**MHI's Response to 2nd round Requests
for Additional Information**

**Topical Report MUAP-07005-P(R3)
Safety System Digital Platform -MELTAC-**

**MHI's Responses to 2nd round RAI
on
Topical Report MUAP-07005-P(R3)
"Safety System Digital Platform -MELTAC-"**

The RAI, "Request For Additional Information 07/01/2009 US-APWR TOPICAL REPORT: Safety System Digital Platform – MELTAC MUAP-07005-P(R3)" , was issued on July 1st, 2009.

Figure 4.3-5 Example of connection configuration of Data Link configuration

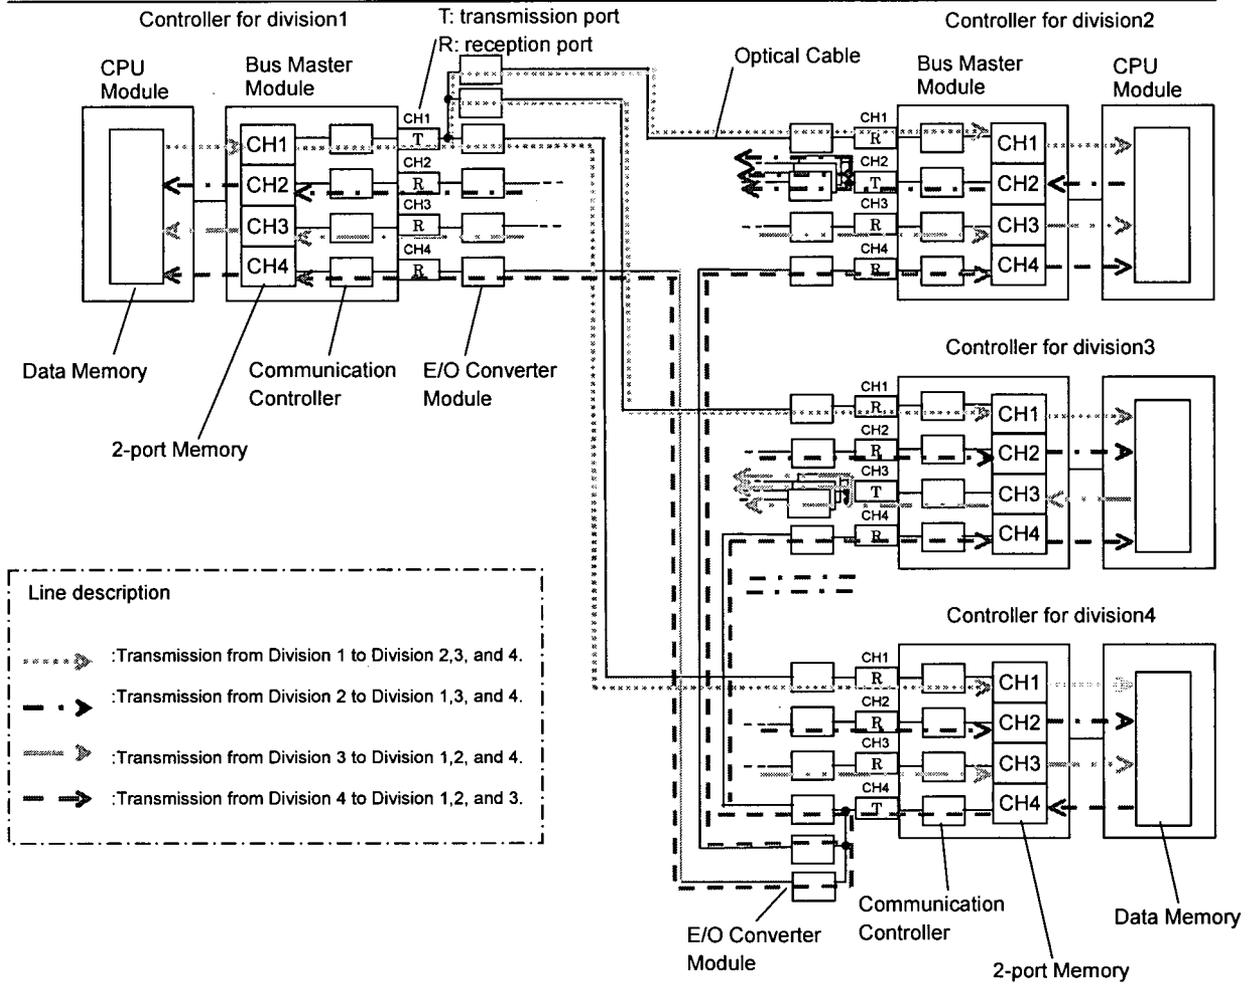
Original Question (partial): Data Link communication is discussed in Section 4.3.3.1, Configuration. The various interconnections for the communication systems are listed and named in the topical report. The information describes the network connections but does not give a graphical representation. No information is provided that would substantiate the claim that the communications network design provides physical, electrical or functional isolation of the interconnections at any level of the communications stack.

NRC Supplement: Figure 13-1 and text should be included in the topical report.

Figure 4.3-5 Data Link Configuration in Section 4.3.3.1 of Topical Report MUAP-07005 will be replaced by the following figure described in the response of 1st RAI-13.

Section 4.3.3.1 Configuration will be revised as follows:

Figure 4.3-5 provides a graphical representation of the data link connections between redundant safety divisions. This figure shows all the data link components and the example of connection configuration when CH1 of Controller for division1 is transmission port(T), CH1 of Controllers for other divisions is reception port(R), CH4 of Controller for division4 is transmission port(T), and CH4 of Controllers for other divisions is reception port(R).

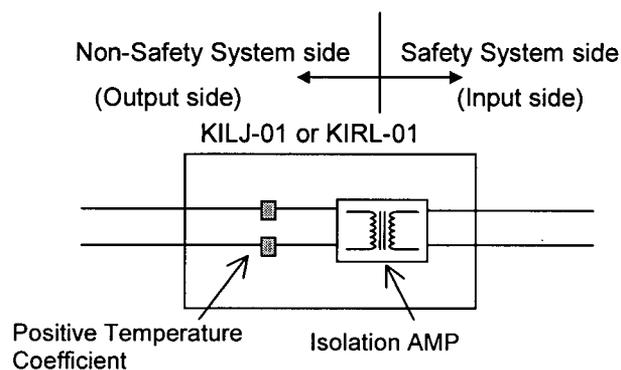
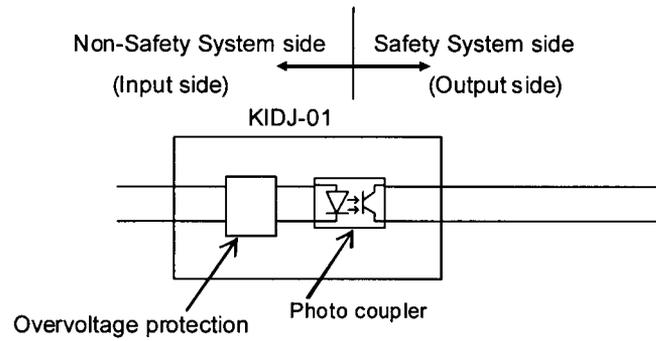
At the Jan. 22, 23 meeting MHI agreed to provide design information of the Isolation Modules identified in Section 4.1.2.3. Either by including in this Section or by separated docketed material, at a minimum the information should include:

1. Specific information, should be provided to explain the voltage isolation method (e.g. Transformer, opto-coupler) and current interrupting / limiting method (e.g. Thermistor, voltage regulator) by schematic or detailed description, of the circuits involved, how isolation circuit is maintained under all conditions and inputs.
2. How they are tested during manufacturing and production
3. How they are included in the equipment qualification program

For the information on the isolation module, we will add the description and figures below in the Topical Report, Section **4.1.2.3 Isolation Module**. In addition, a description of the qualification testing will be added to Section 5.5. Schematics and qualification reports were provided at the MELTAC audit in Kobe.

The figure below shows the internal configuration diagram of the analog isolation modules KILJ-01 and KIRJ-01. For common mode faults, the input and output are electrically isolated by the isolation amplifier. The positive temperature coefficient device (e.g. PolySwitch™) is used to limit overcurrent conditions for transverse mode faults. The positive temperature coefficient device raises its resistance value when it is heated by sustained overcurrent conditions.

The figure below shows the internal configuration diagram of the binary isolation module KIDJ-01. For common mode faults, the input and output are electrically isolated by a photo coupler. The over voltage protection circuit limits the current for transverse mode faults. The over voltage protection circuit consists of a transistor, FET, and high-resistance. The circuit converts to high resistance to restrict the current when a voltage that exceeds the FET gate voltage is supplied.
